Product Change Notice (PCN)

PCN Number: **PCN-0450879R-01**

Product(s) Affected: **PJ1-021**

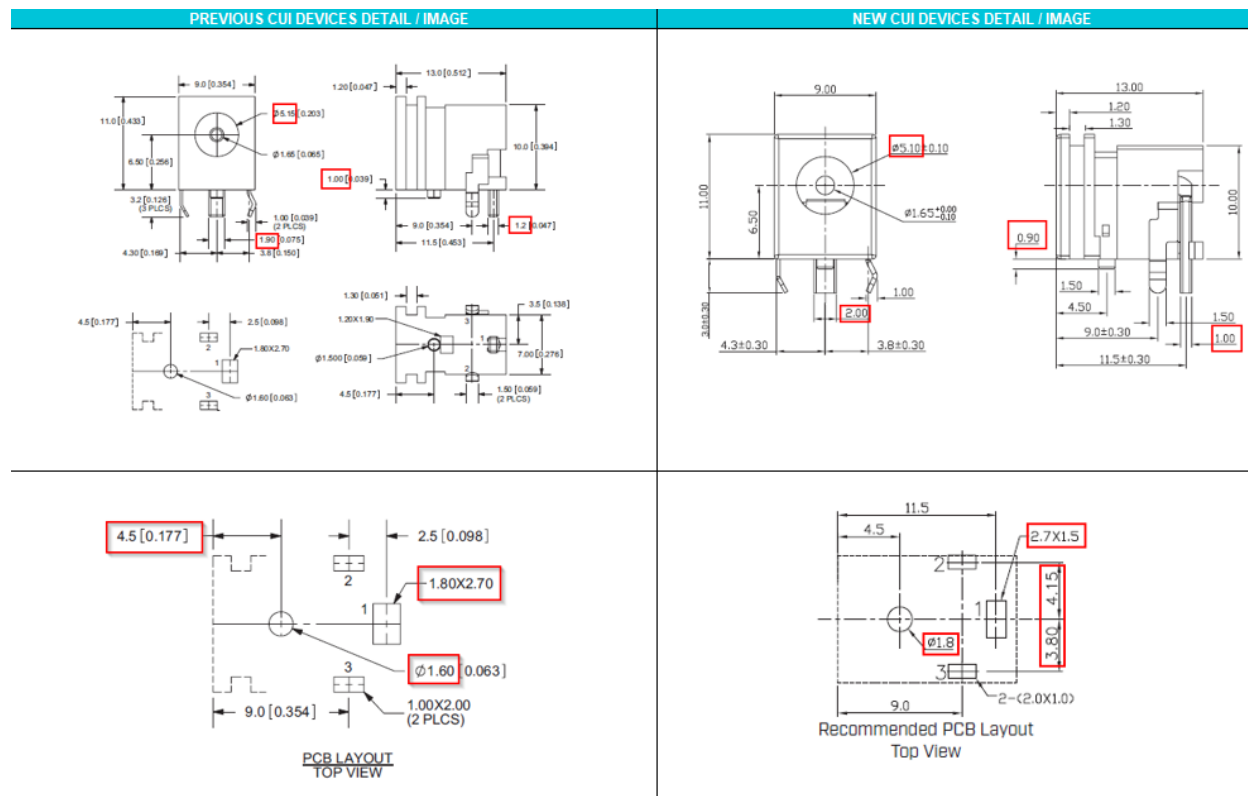
Description of Change: **Minor Housing and footprint differences. Material Change on the housing and terminals. See image Below**

PREVIOUS CUI DEVICES DETAIL / IMAGE			NEW CUI DEVICES DETAIL / IMAGE			
	MATERIAL	PLATING		DESCRIPTION	PLATING/COLOR	
center pin	copper	silver		center pin	brass	nickel
terminal 1	copper	silver		terminal 1	brass	nickel
terminal 2	copper alloy	silver		terminal 2	bronze t=0.30	silver
terminal 3	brass	silver		terminal 3	brass t=0.40	silver
plastic	PBT			housing	PBT (UL94V-0)	black

<p>MATING PLUG Jack Insertion Depth: 8.5 mm</p>	 <p>MATING PLUG Jack Insertion Depth: 8.7 mm</p>
---	--
